RE: Comments on Preliminary Flood Insurance Rate Map and Flood Insurance Study for the City of Ukiah Including the Areas Near Orrs, Gibson, and Doolin Creeks

To	City of Ukiah		
Copy to	GHD Files		
From	GHD and the City of Ukiah	Tel	+1 415 283 4970
Subject	City of Ukiah FEMA Map Revision Review	Project no.	12589077

This memorandum summarizes GHD's and the City of Ukiah's preliminary review of the Mendocino County Map Revision (Orrs, Gibson, Doolin, and Zone AE) Updates, prepared by FEMA Region 9 and presented to the City of Ukiah (the City) in July 2024. This review included the preliminary Flood Insurance Study (FIS) and Flood Insurance Rate Map (FIRM) dated July 10, 2024, and the hydraulic analysis model and data provided by the FEMA's STARR II contractor team on September 11, 2024.

Figure 2 Preliminary FIRM Panel 06045C1514G (July 10, 2024)

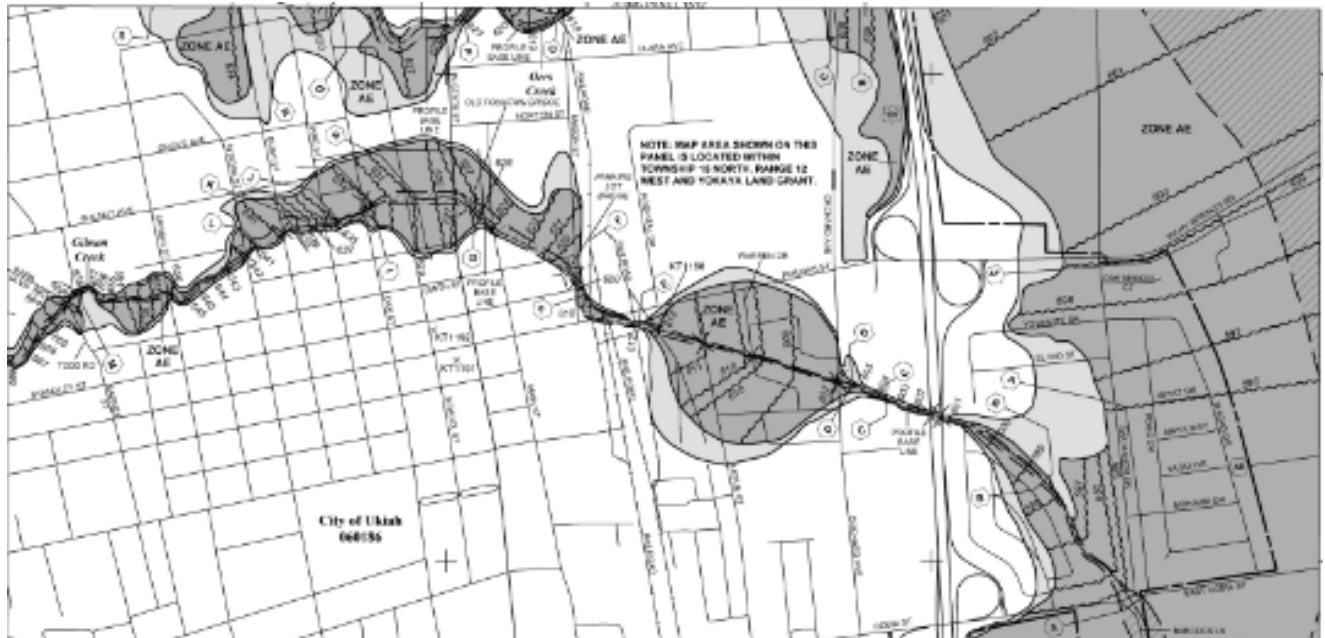
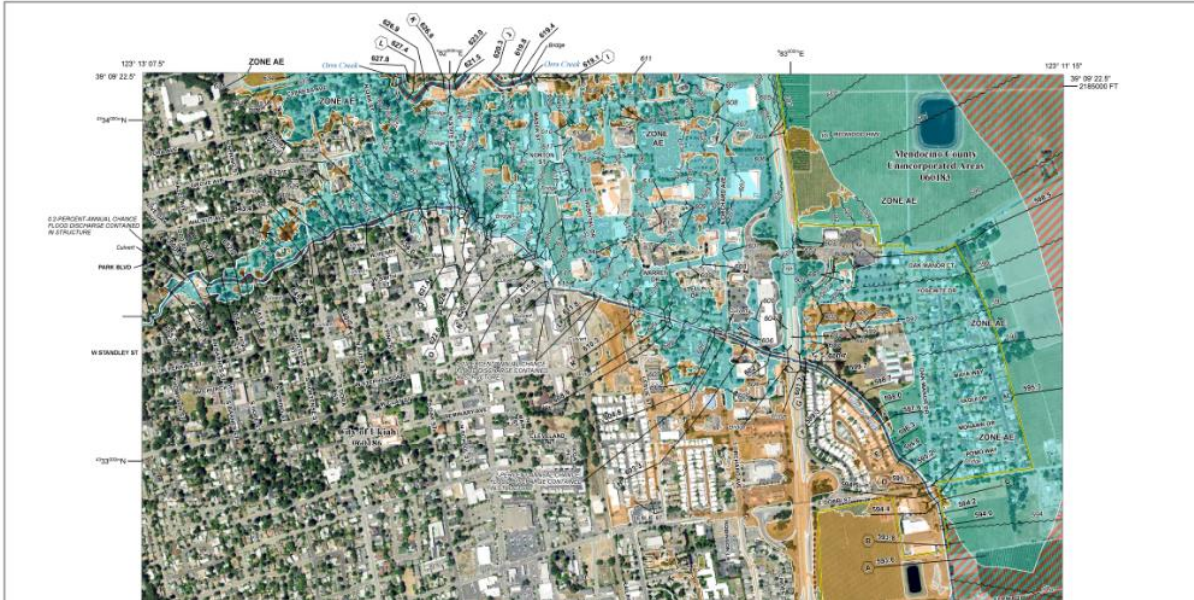
The preliminary FIRM shows proposed changes in the floodplain extent in the City. The preliminary FIRM generally shows additional floodplain areas, especially for Zone A and Zone AE. For example, in FIRM panel 06045C1514, a significant portion of the urban area between Orrs Creek and Gibson Creek is remapped as floodplain Zone AE, as shown in Figures 1 and 2. The changes are partly due to a different hydraulic analysis approach in this floodplain area. The hydraulic analysis for the effective FIRM was based on one-dimensional (1-D) creek modeling. The new hydraulic analysis for the preliminary FIRM included 1-D channel modeling with a two-dimensional (2-D) floodplain model to provide additional resolution to the floodplain flooding. These updates of floodplain extents in the preliminary FIRM may trigger new flood insurance requirements in the area.

The impetus for this review of the preliminary FIRM update concerned the large expansion of the SFHA along and between Orrs Creek and Gibson Creeks (Figures 1 and 2) within the City (Tim Eriksen, P.E., City of Ukiah City Engineer, personal communication). Based on comments and feedback from a long-time local engineer (Ron Franz) who has completed hundreds of Elevation Certificates in the City limits, flooding in these expanded SFHA areas has not occurred, even during the December 2005 flood event (Ron Franz, personal communication). For reference, the December 30, 2005 flood event on the Russian River near Ukiah (USGS station: 11461000) observed peak flow was 22,600 cfs and exceeded the 1% annual exceedance flow (100-yr event) of 22,100 cfs estimated by the USGS (Gotvald et al. 2012) for this station.

Figure 3 Army Corps of Engineers recorded High Water Marks for the December 1964 flood event—note lack of inundation within the majority of the City of Ukiah

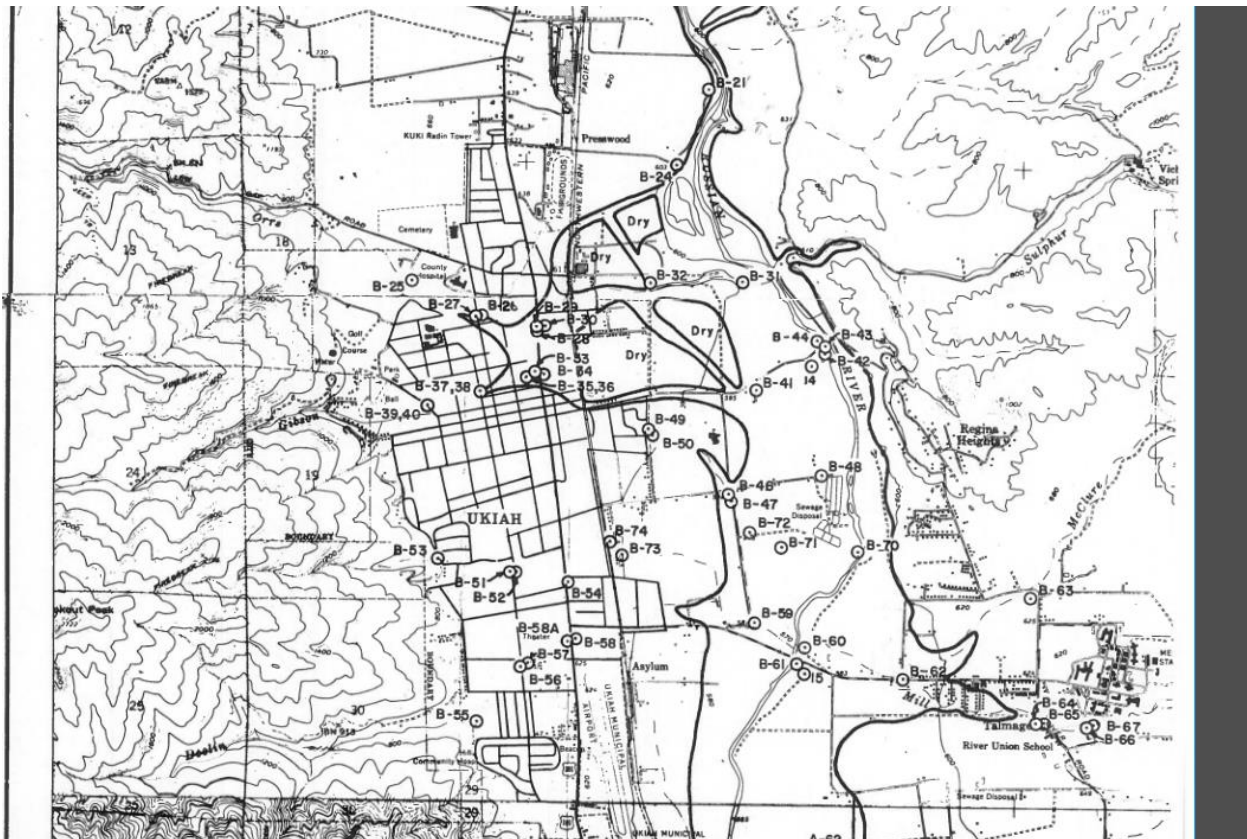
In addition, the largest known flood on record (December 1964), largely considered to exceed the 100-year flood depths, was surveyed by the Army Corps of engineers within the City limits. Figure 3 and Attached is the figure produced by the ACOE, which clearly shows the floodplain extents and the lack of inundation within the City limits. While we understand that channel conditions and hydrology can change over time, it is hard to believe that the current 100-year floodplain is so much larger and deeper in extent than that seen during the 1964 event.

Figure 4 North Spring Street Inundation (FEMA Preliminary 100-Year)

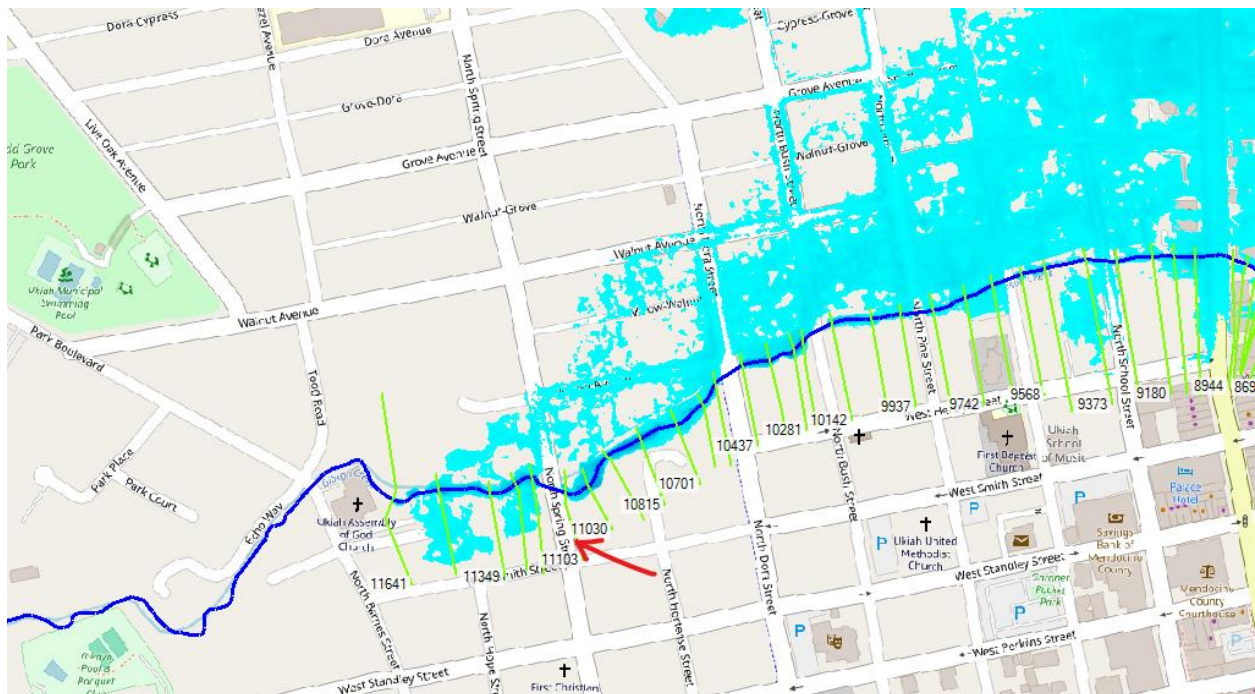
The North Spring Street crossing is the first structure on Gibson Creek in the HEC-RAS Model (Figure 4). During the 100-year storm event, the FEMA model predicts flow overtopping the crossing and contributing to floodplain inundation (Figure 5). The City Engineer, who grew up at 345 N. Spring Street near the creek and Spring Street intersection, reports no history of flooding in this area.

Figure 7 North Pine Street Crossing and overtopping from the Preliminary FEMA Model

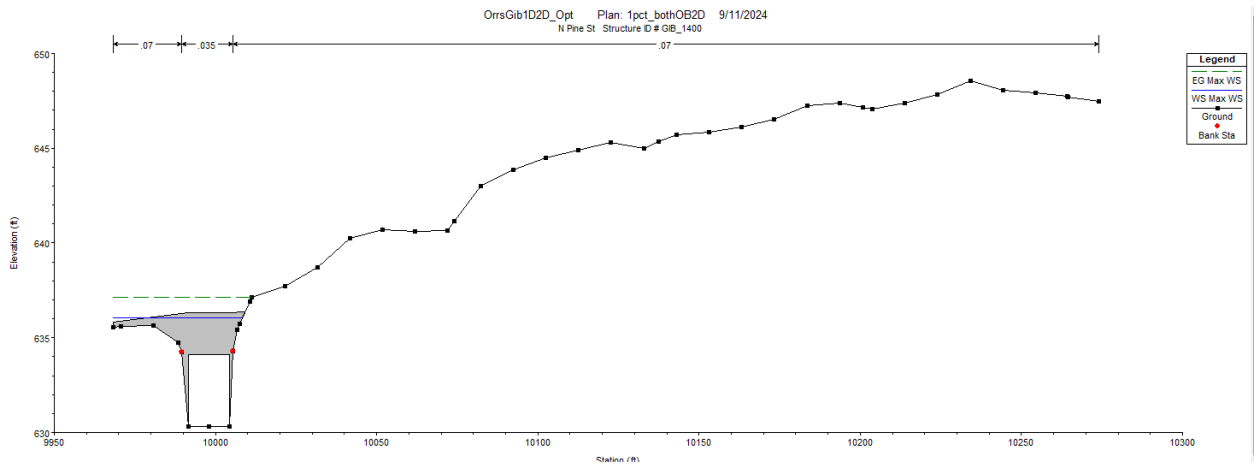
The FEMA Preliminary model predicts over 140 cfs leaves the Gibson Creek channel between the North Pine Street crossing and the North Oak Street crossing. Both of which City staff report no history of flowing issues in past. Assuming the structure geometries are entered correctly into the model, excessive peak flows may result in artificial flooding sources in these locations.

The City Engineer has never observed flooding in these locations. Additionally, the model's cross sections show the 10-year event as having higher water levels than the 100-year event, which is inaccurate. The 10-year event has never overtopped this area, raising concerns that the model's inputs may be incorrect.

Figure 9 Orchard Avenue Inundation (FEMA Preliminary 100-Year)

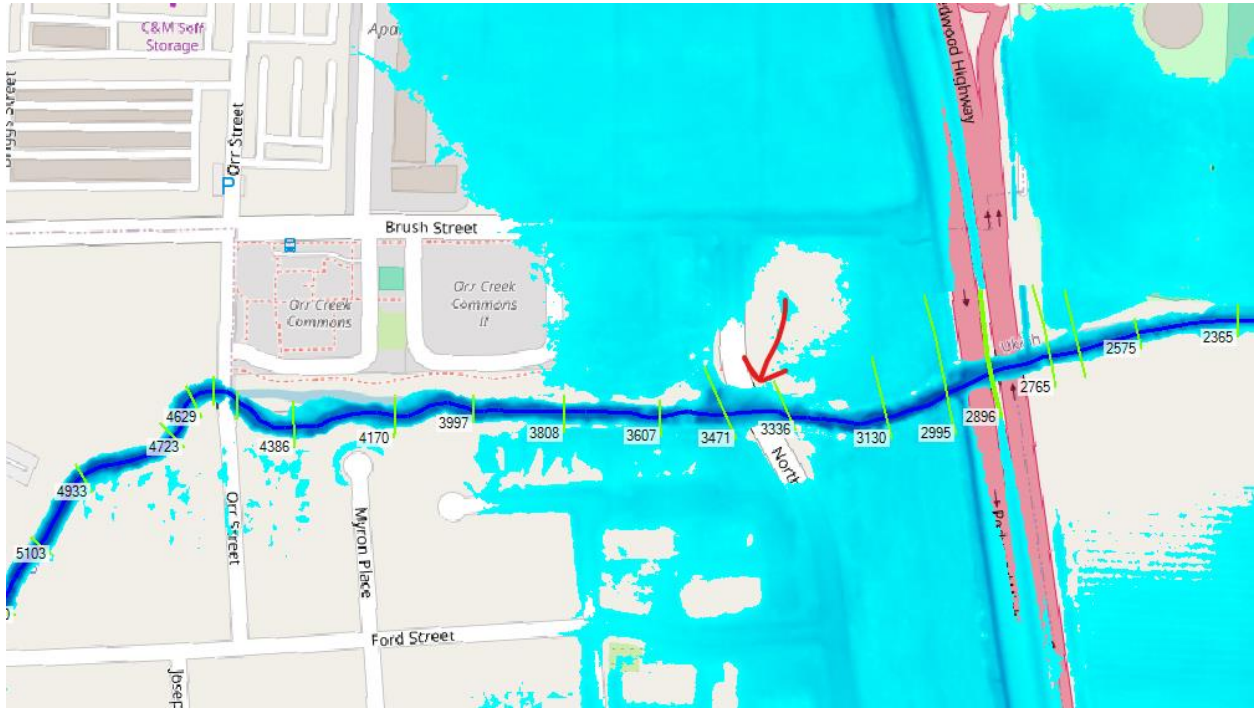
The Orchard Avenue Bridge was built in 2012 and was subsequently required to be built to modern building standards including building for the conveyance of the 100-year design storm event. The FEMA Preliminary Model predicts the backwatering of the Orrs Creek Channel upstream of the bridge resulting in over 500 cfs leaving the channel to the right and left floodplain areas. City staff report no known flooding instances at this location, indicating an unrealistic prediction of flooding in this area.

Figure 11 FEMA 10-Year Max. Inundation depth

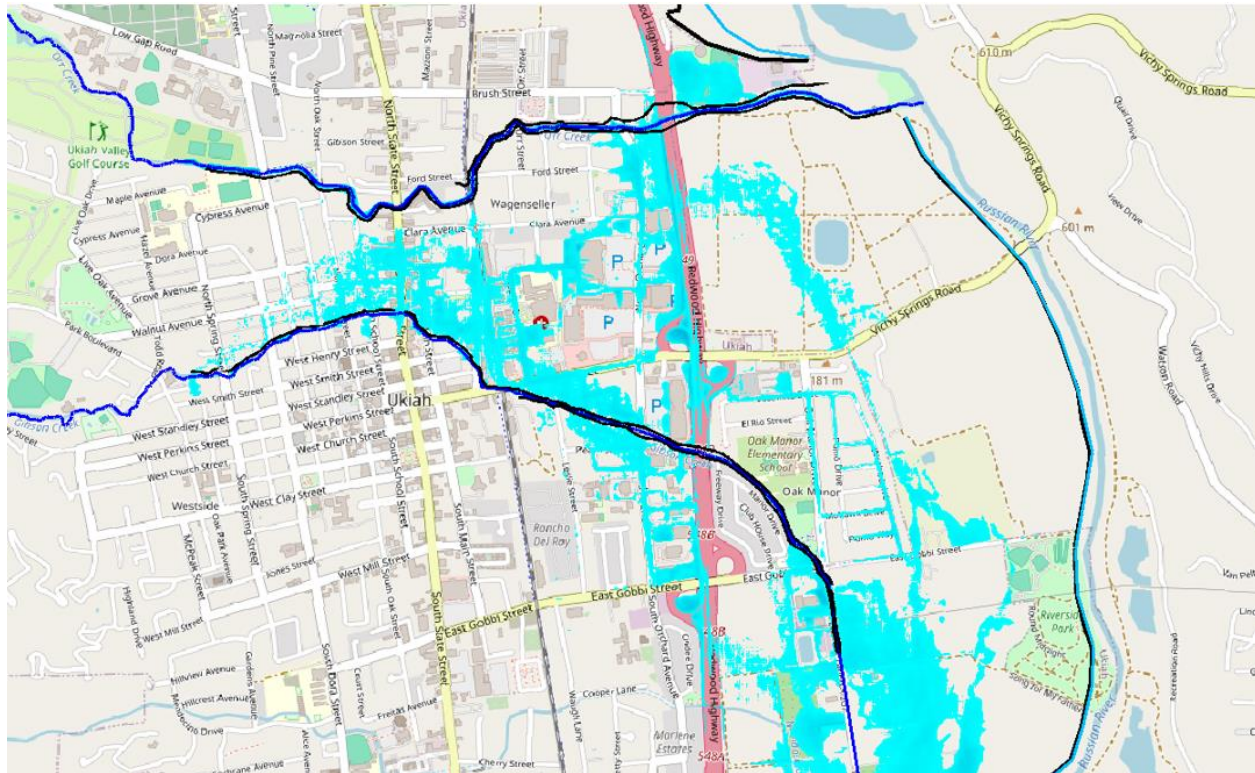
In addition to the number of the crossings within Orrs and Gibson Creeks which show overtopping during the 100-year event, the provided HEC-RAS model developed by the STARR team also includes floodplain inundation associated with the 10-year storm event (Figure 11). Over the past 10 years, the City of Ukiah has experienced a number of storms close to and exceeding the rainfall totals of a 10-year event. City Public Works and City Engineers both report no significant flooding inundation with the City. Compare that to the predicted 10-year inundation extents and it raises a number of questions to the validity of the results provided by the HEC-RAS model. In some places the model is predicting over a foot of depth during the 10-year event. For example, the Orchard Avenue Bridge previously discussed and installed in 2012 shows significant channel overtopping during the 10-year event. A bridge crossing that City staff have never seen reach anywhere close to the top of bank, let alone overtop and contribute to floodplain inundation.

Figure 12 FEMA 10-Year Max. Inundation depth in Peach Street Subdivision

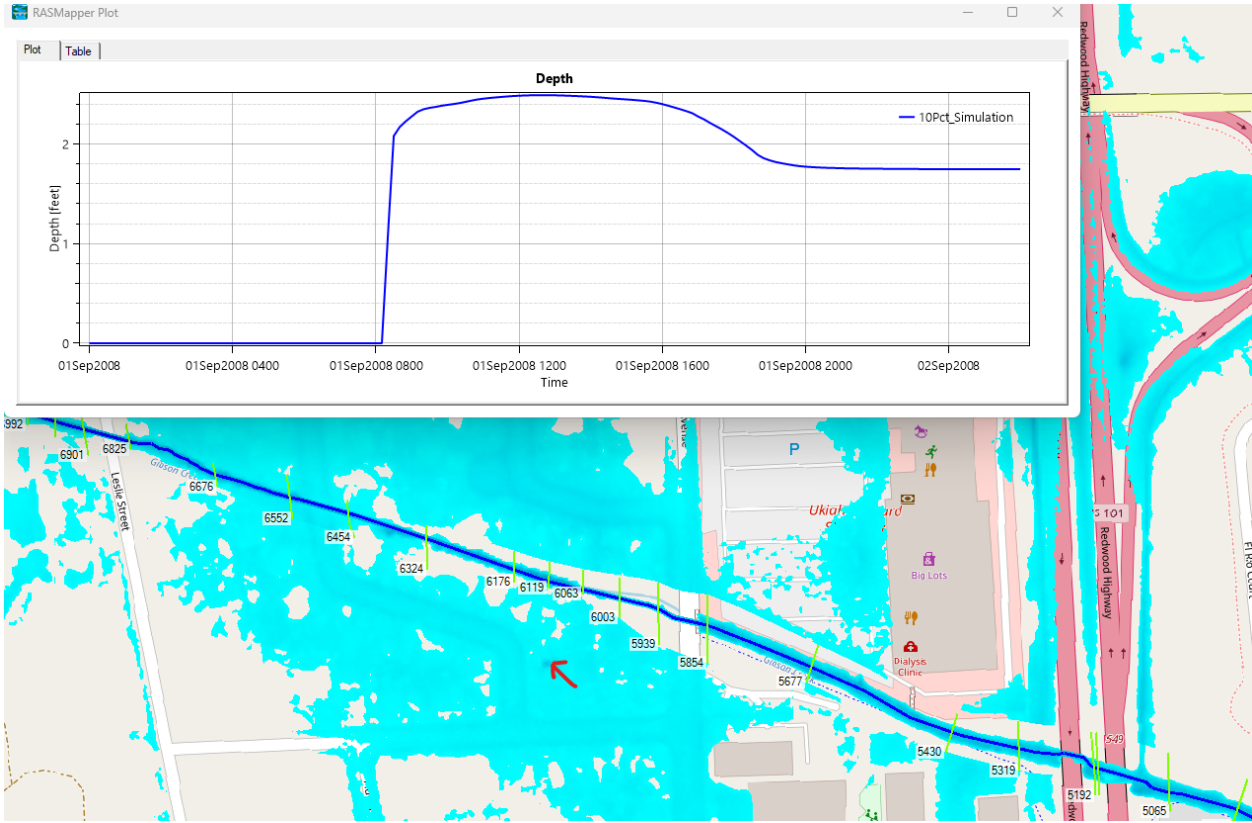
The model shows that the neighborhood bordered by Peach Street, Orchard Avenue, Leslie Street, and Perkins Street would be completely inundated in a 10-year event. The city engineer has never seen any flood activity in a 100-year or 10-year event. To make it worse, the model shows that in a 10-year event the water depth would be 2.5 feet (Figure 12).
